Appendix B1
Greenhills to City
Centre
– 1st Non-Statutory
Public Consultation
Submission Report

Corridor 9 – Greenhills to City Centre

Emerging Preferred Route – Public Consultation Report 2018/2019

Section 9: Crumlin Road to Coombe Hospital

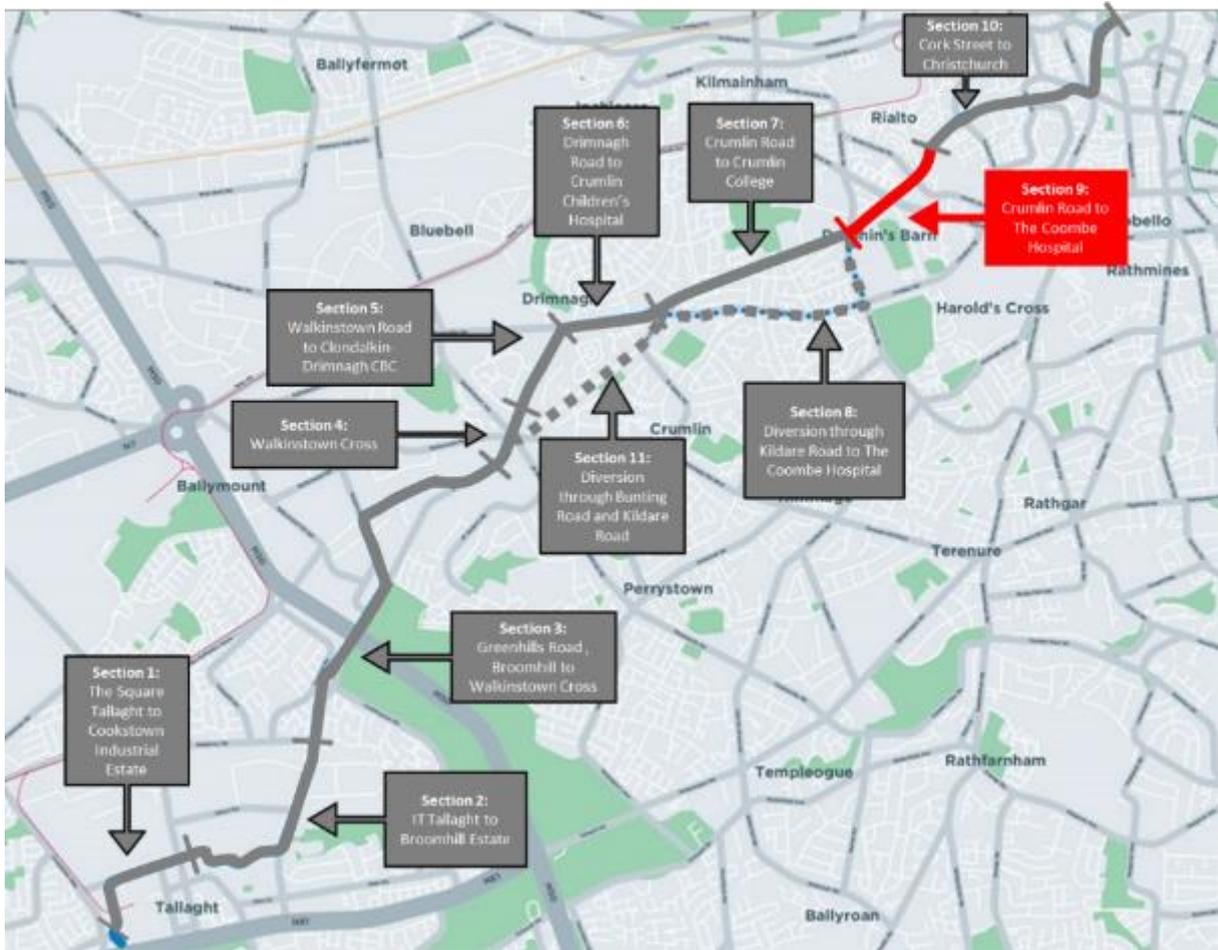
- Right turn from Sundrive Road onto Crumlin Road has potential to be dangerous depending on the traffic signalling.
- Increase in road width and increase in number of lanes seems unrealistic with such little land take.
- Inbound bus stop has been moved away from the shops and will remove an e-car charging space which is unacceptable.
- A casual observation of the existing bus lanes from Crumlin Shopping Centre to Sundrive Road and on Dolphins Barn/ South Circular Road shows that bus lanes are simply being ignored by motorists.

- Dolphins Barn needs to be made safer for cyclists instead of adding extra turning lanes for motorised traffic.
- Removal of an inbound bus stop opposite the Loreto School.
- No provision of cycle facilities yet there is space on this road for widening to include cycle lanes.
- No crossing facilities for pedestrians at Grand Canal side of Dolphin Road crossing.
- Sufficient space to provide bus bypass lanes for cyclists.
- The cycle tracks on Dolphins Barn Bridge over the canal look less than 2m. The hatching in the middle of the road should be removed to widen the cycle track.

- “No left turn” implemented onto South Circular Road.
- Bike lanes need to go behind bus stops (bus stop bypasses).
- There is ample room at the South Circular Road junction to provide a Dutch Style Junction with fully segregated cycle and pedestrian facilities.
- Directly outside the Coombe, the pavement is currently always blocked by vehicles parking all four wheels on the footpath and kerbs. More aggressive parking deterrents as seen at the Wilton Terrace/ Grand Canal area should be implemented here. Grass verges and the plantation of trees would also mitigate this issue.
- The addition of an outbound traffic lane should be reversed in order to provide an inbound cycle lane instead.

Section 10: Cork Street to Christchurch

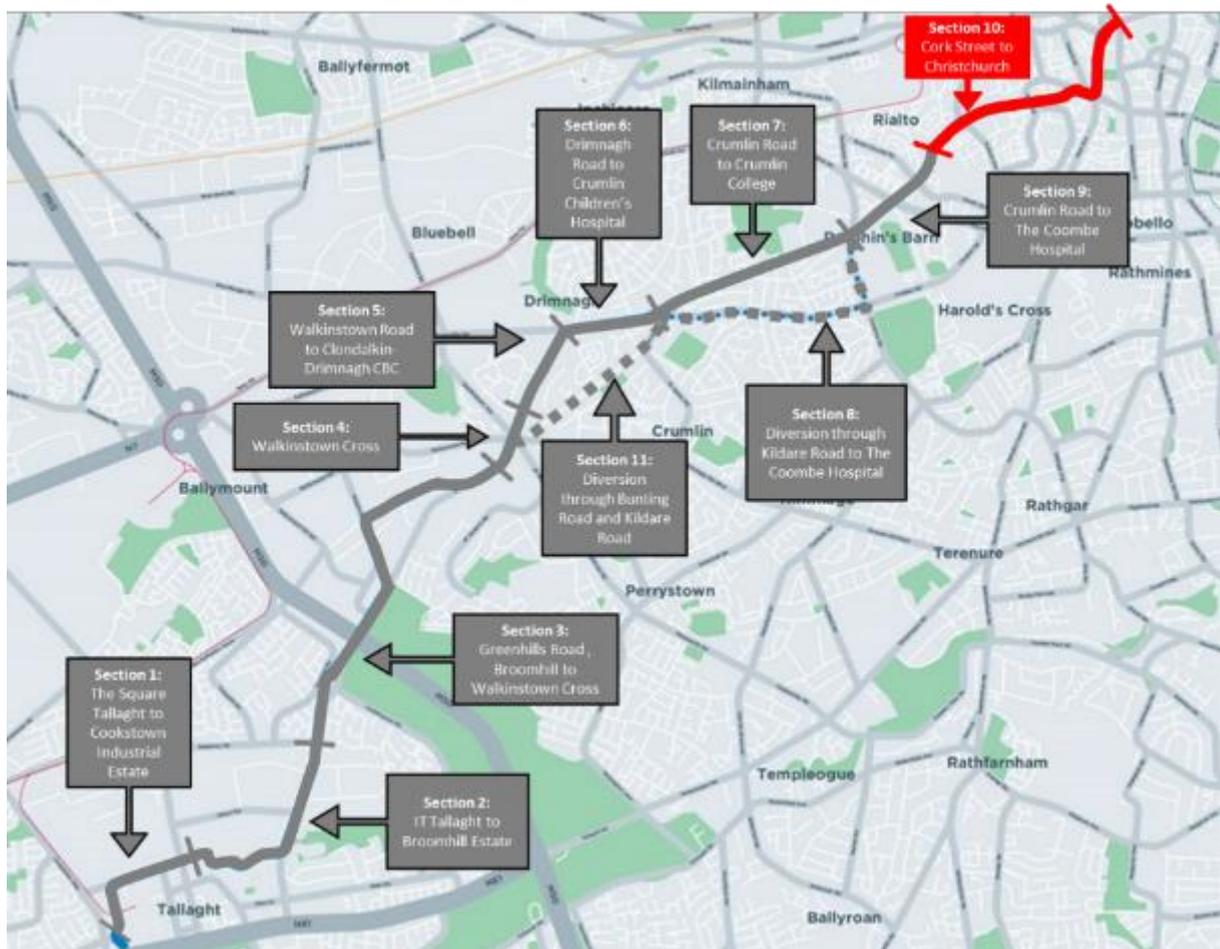
- Unacceptable inline bus stops.
- Junction improvements at Ardee Street are welcomed.
- Sufficient space here to provide bus stop bypasses.
- Bus stop locations should be rationalised; inbound stops too close together.

- The Dean Street/ Kevin Street junction is currently very intimidating. A Dutch Style redesign should be considered.
- There was a suggestion to provide a 3 second or so head start bicycle only green light ahead of traffic in all directions to allow cyclists to safely cross the junction freely before traffic.

- Unacceptable inline bus stop at Patrick Street. It is noted the Toucan Crossing is already abused by cyclists.
- The removal of trees along the central meridian is not welcomed; there is no reasoning for this as the road is wide enough.
- Bus lane should be marked along Christchurch Place on both sides of the road.
- The cycle lane in front of the bus stop on Nicholas Street is unsafe.
- The existing taxi rank outside of Jury's Hotel on Christchurch Place regularly sees taxis parked in the bike lane. Proper segregation needs to be considered here, possibly a free standing kerb and bollards between the bike lane and taxi rank.
- The trees should remain after the central median is removed, especially with the current climate chaos.

Section 11: Diversion through Bunting Road and Kildare Road

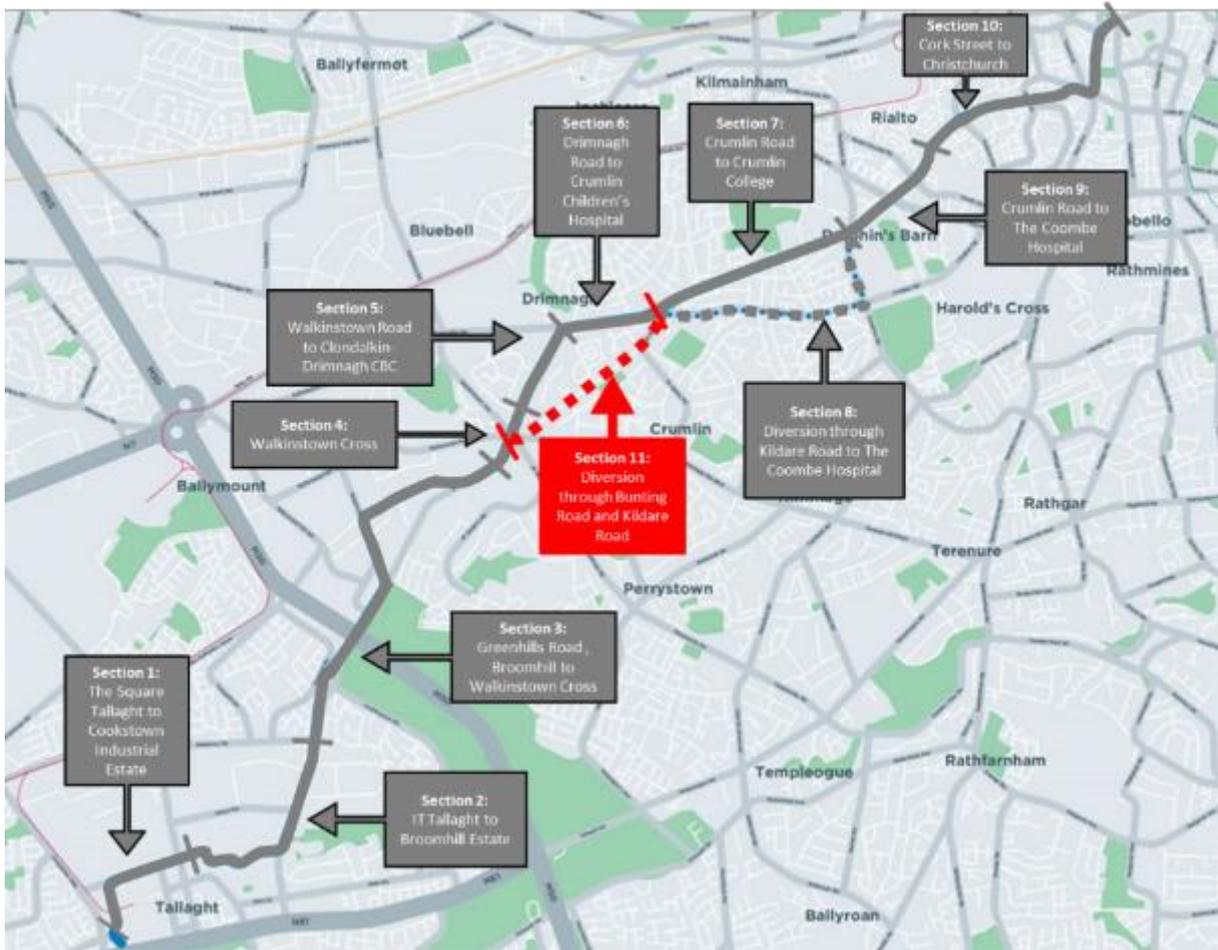
- Desire lines of cyclists need to be considered. They will take the most direct route rather than a diversion as Bunting Road.
- Bunting Road has had a history of fast through traffic, which is why severe ramps were installed. Filtered permeability and removal of existing ramps should be considered.
- Footpath parking is extremely common on Bunting Road causing blockage for cyclists. Bunting Road should be designed in a manner to mitigate this issue.
